SUBJECT: NuScale Power, LLC Response to NRC Request for Additional Information No. 386 (eRAI No. 9316) on the NuScale Design Certification Application

Response to Request for Additional Information Docket No. 52-048

eRAI No.: 9316

NRC Question No.: 03.09.02-54

Figure 2-4 Steam piping downstream of steam nozzles

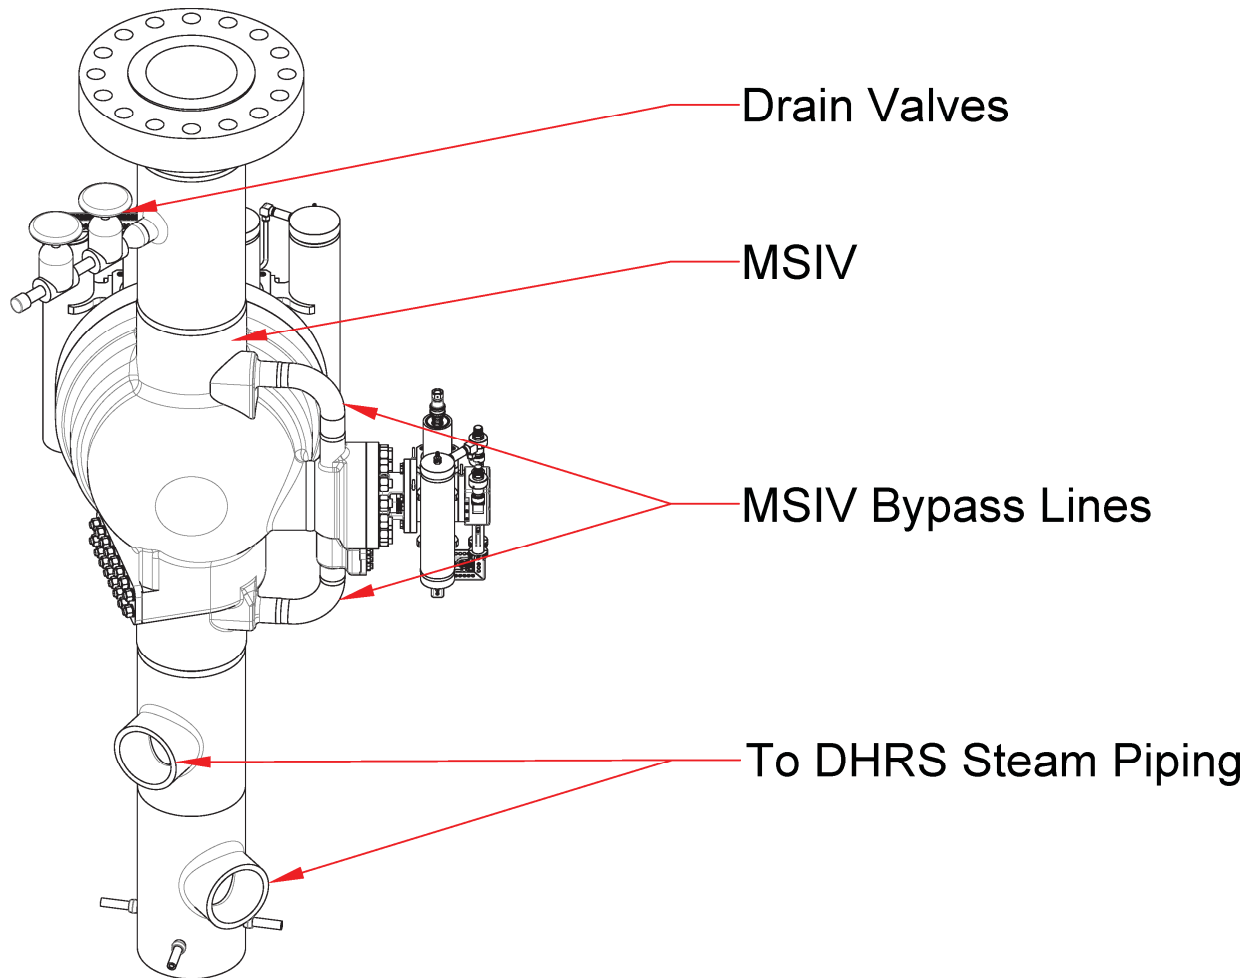
Provide the detailed information on acoustic resonance (AR) assessments to the CVAP report as originally requested in RAI 8884, Question 03.09.02-7, particularly on the decay heat removal system (DHRS) standby modes. Given that strong acoustic resonances excited by second order shear layer flow instabilities have been observed in the main steam lines of boiler water reactors (BWRs) it has been common practice for licensees requesting Extended Power Uprates (EPU) or those proposing new plant designs to confirm that first and second order shear layer instabilities do not lock-on to sidebranch acoustic modes and damage valves or generate acoustic loads which could damage other components including reactor internals. Other evidence of the ability of 2nd order instabilities to excite acoustic resonances are available in Ziada and Lafon, "Flow-excited acoustic resonance excitation mechanism, design guidelines, and counter-measures," Applied Mechanics Reviews, Vol. 66, Jan 2014. Expand the NuScale AR assessments, particularly in the DHRS, to include second order instabilities. Also, given the small margin against AR at the primary shear layer modes, explain in detail how AR will be assessed and, if necessary, mitigated during initial startup or other testing. Without the information, the staff cannot reach a reasonable assurance finding on the structural integrity of the reactor internals components to withstand the adverse effects of vibration.

2.3.1.1 Steam Piping, Plenum Exit Nozzle, ~~and Main Steam Isolation Valve, MSIV~~ Upstream and Downstream Bypass Lines, CNTS MS Drain Valve Branch

The SGS piping includes the steam piping inside containment (see Figure 2-4). The SGS steam lines initiate at the steam supply nozzle safe ends on the steam plenums and terminate inside the CNV at the CNV penetration nozzle safe ends. Outside the CNV, the steam lines are termed CNTS steam piping through the MSIV to the NPM disconnect flange. The CNTS steam lines have three regions of side branches that are closed during normal operation: the tees to the DHRS steam lines, connections upstream and downstream of the MSIV body to the bypass MSIV, and branch lines to the CNTS MS drain valves. ~~are connected to the DHRS.~~

These components meet the screening criteria for AR. Vortices can potentially form off the leading edges of transitions within these components. Similar shedding could potentially occur due to shedding off the main steam valve bodies. When shedding frequencies become close or equal to the acoustic frequencies of the downstream piping and valve or nozzle bodies, AR can occur. No other FIV phenomena are credible for these regions.
